SYDNEY WESTERN CITY PLANNING PANEL

COUNCIL ASSESSMENT REPORT

Panel Reference	PPSSWC-30
DA Number	DA-585/2019
LGA	Liverpool City Council
Proposed Development	The application seeks consent for the following land uses and building envelopes on the site: • Building envelope with a maximum height of RL 43.45 for the purpose of an information and education facility – public library use, and public domain; • Building envelope with a maximum height of RL 84.25 for the purpose of a public administration building use and / or a commercial premises or child care centre uses; • Building envelope with a maximum height of RL 118.85 which all accommodate either commercial premises, educational establishments, tourist and visitor accommodation or boarding house (student accommodation) uses; • Landscaping and public domain concept including the provision of a public through site link running north to south through the site, connecting Scott Street to the north through to Terminus Street to the south; • Building envelope for a three-level shared basement car park across the entire site to accommodate parking for all future uses (approx. 413 spaces) and accommodating a public car park to be owned b

Figure 14: Visual representation of proposed building separation variations (towers indicated in darker shades)

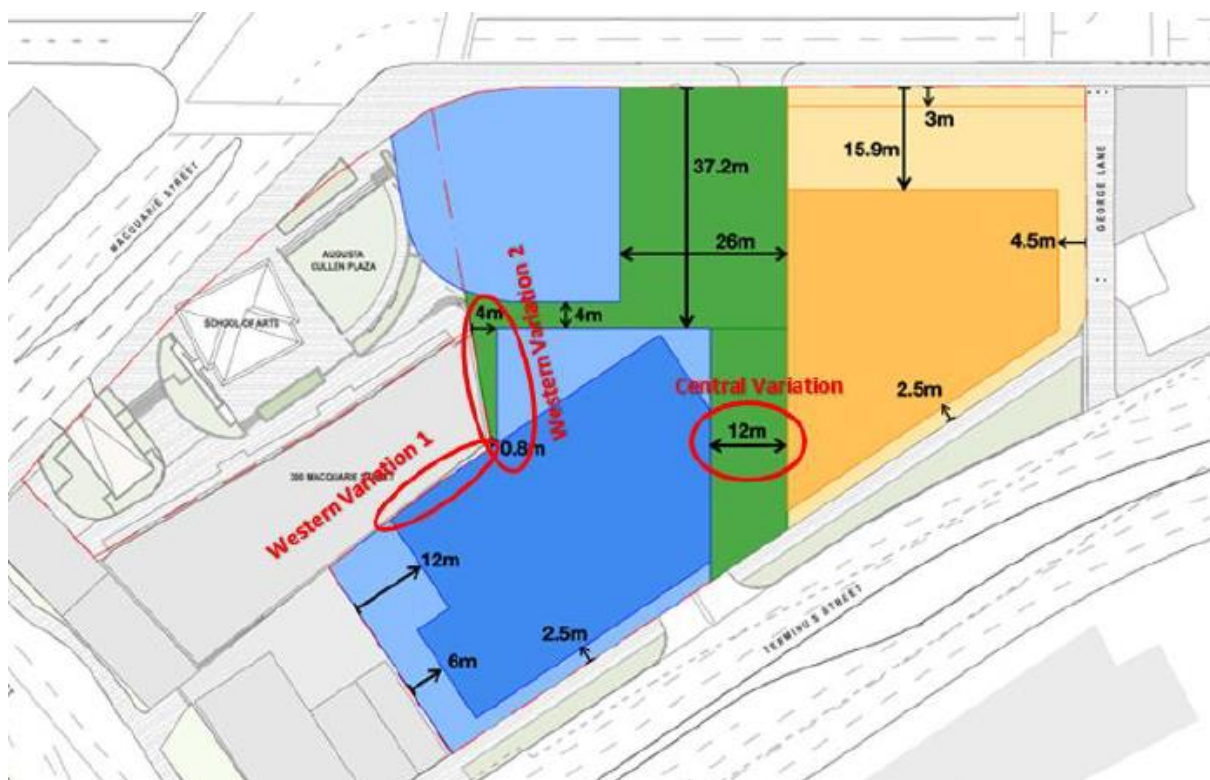
Portions of the proposed building envelope do not comply with the 12m or 28m building separation required under Clause 7.4 (refer to **Figure 14**):

A varied building separation of between 0.8m and 4m is proposed between the northern section of the podium of the south western building envelope and the existing building at 300 Macquarie Street, in contravention of Clause 7.4(2)(d), which requires a minimum separation distance of 12m for parts of buildings between 25m and 45m height. The contravention occurs as the podium is proposed at a height between 25m and 45m in height (RL 56.7) and 300 Macquarie Street is greater than 25 metres in height but less than 45 metres in height. Notably, the eastern edge of 300 Macquarie Street is a blank wall and therefore no apartments or tenancies are oriented toward the site.
